**ADDENDUM #2**

<b>Project</b>	TA Blakelock High School Renovations	<b>Project No.</b>	2215-C
<b>Location</b>	1160 Rebecca Street, Oakville, ON	<b>Date of Issue</b>	2025 04 25
<b>Owner</b>	Halton District School Board	<b>File</b>	2215/7.1.3

This Addendum forms part of the Contract Documents and amends the original Drawings and Specifications, dated 2025 04 17, and all preceding Addenda, as noted below.

7 WASHROOM ACCESSORIES SCHEDULE  
A101 NTS

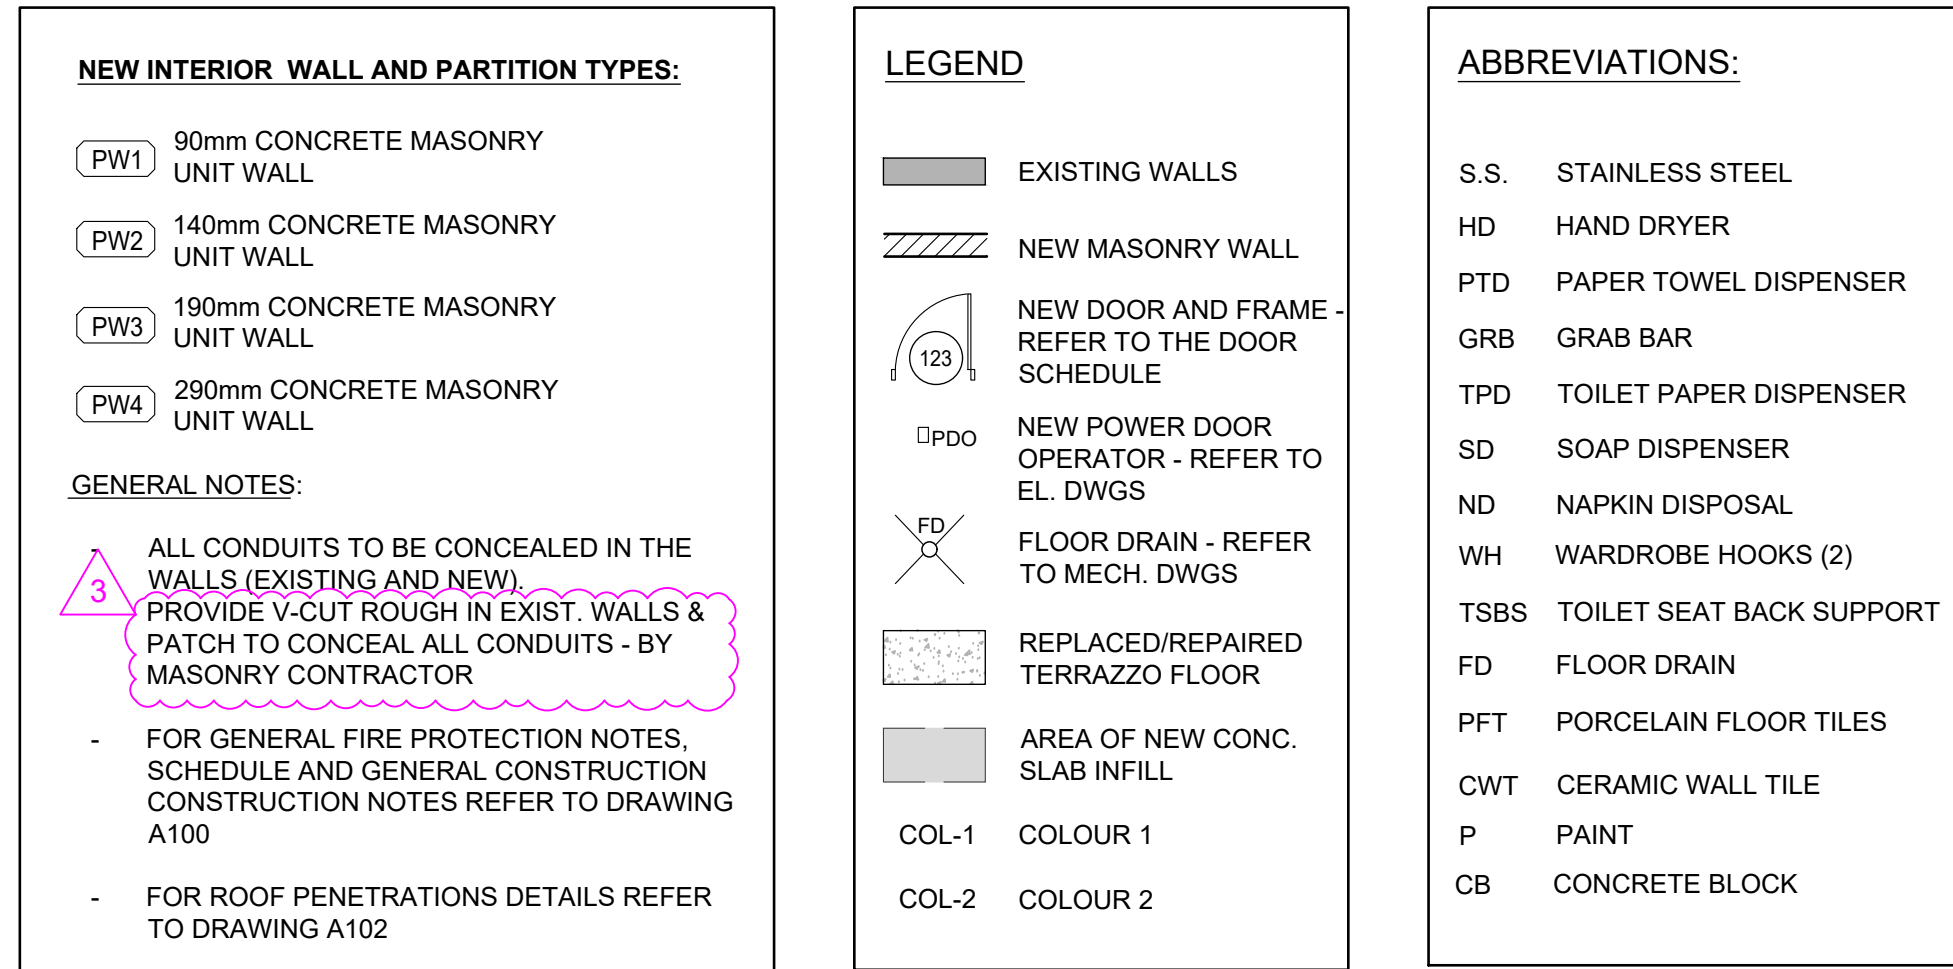
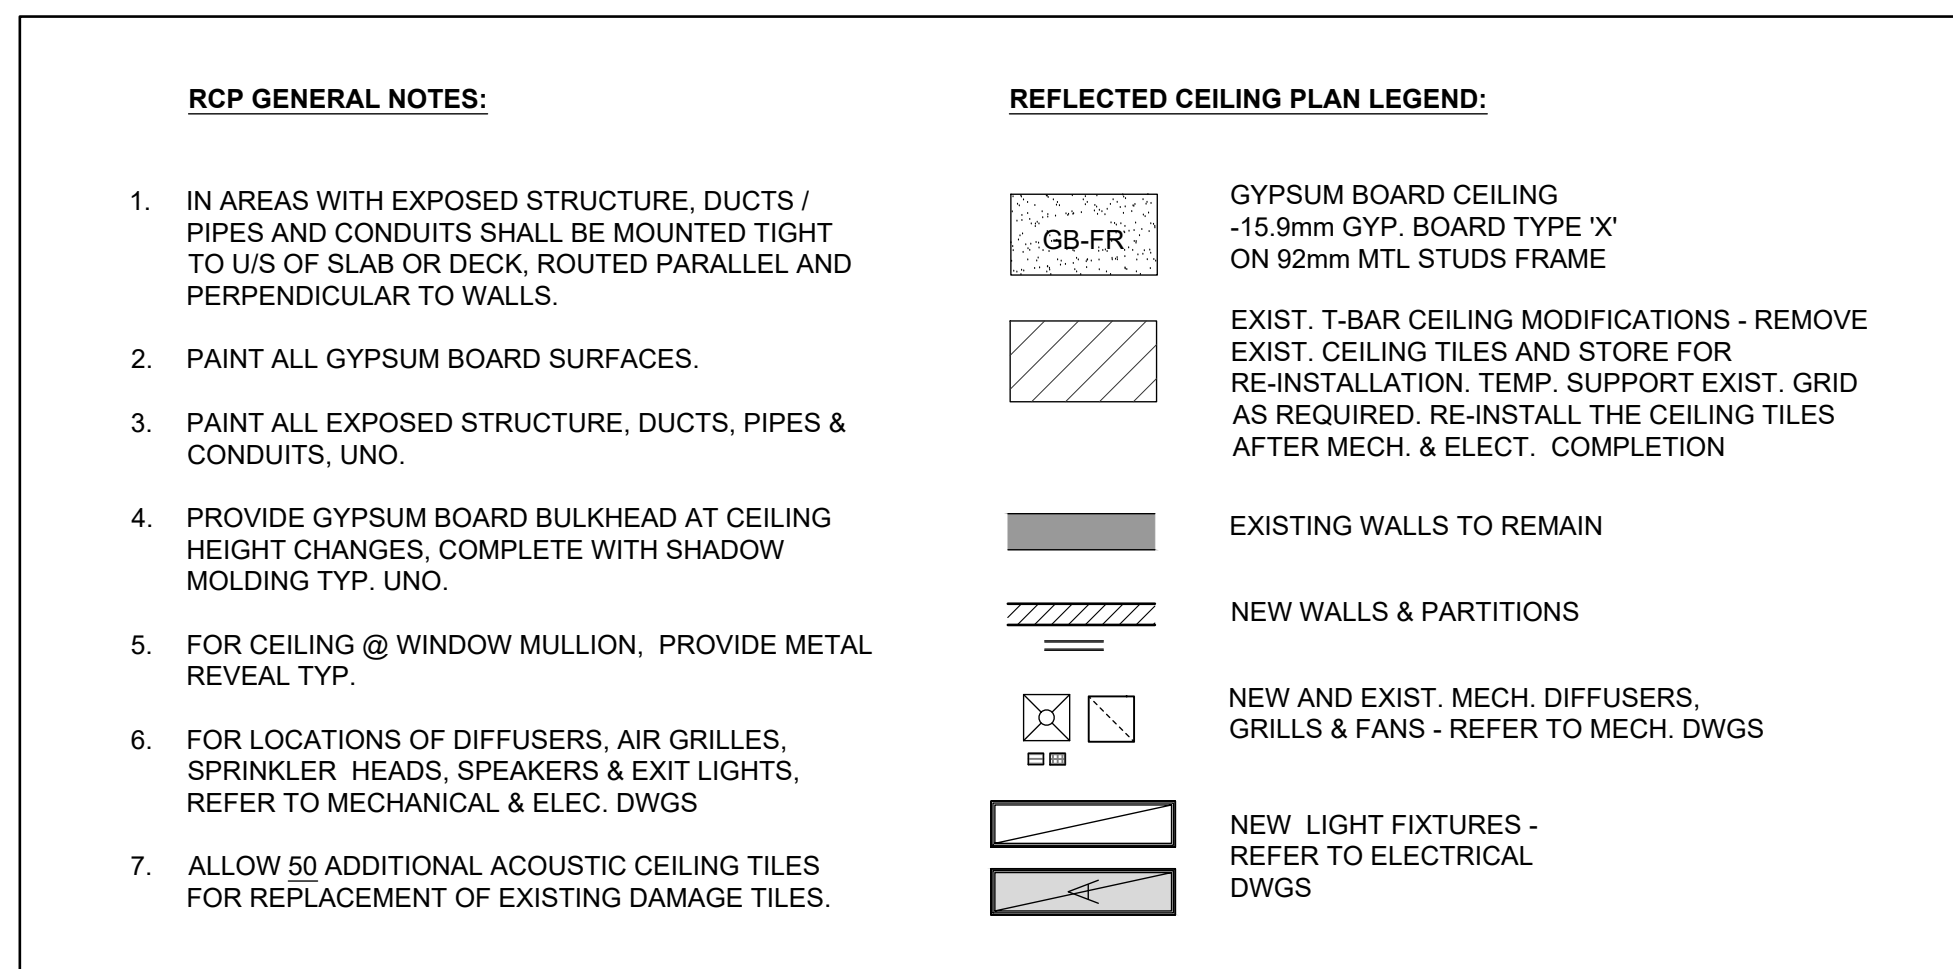
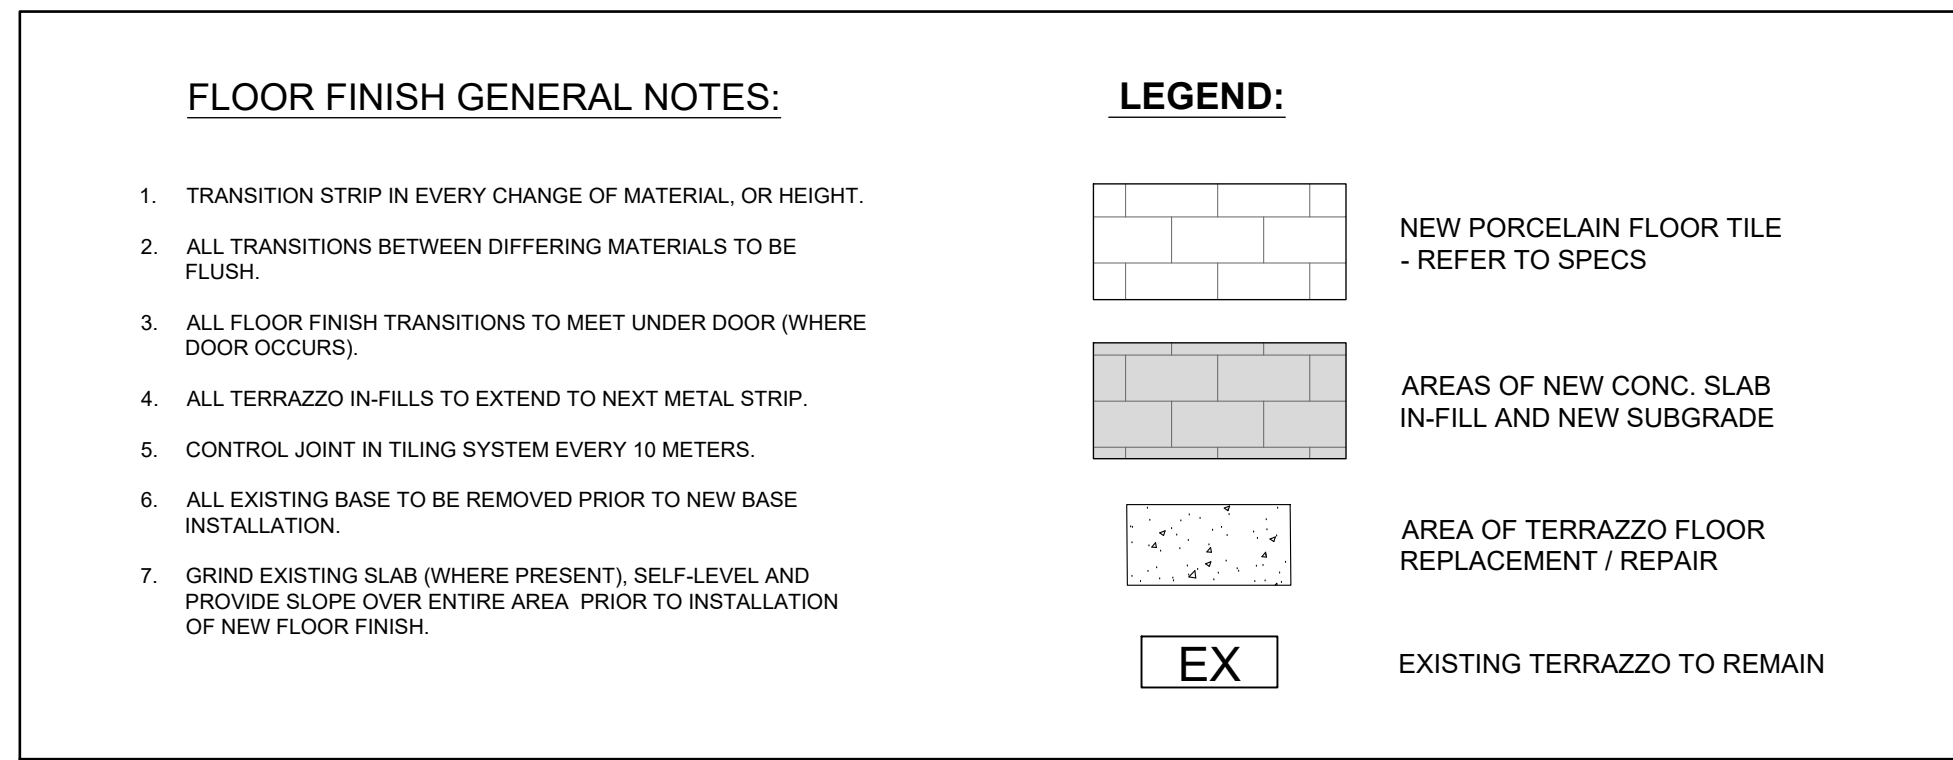
- .1 Interior plumbing wall was shifted to add insulation on the inside of the existing exterior wall.
- .2 Additional notes were added.
- .3 Washroom Accessories Schedule was added to the drawing.
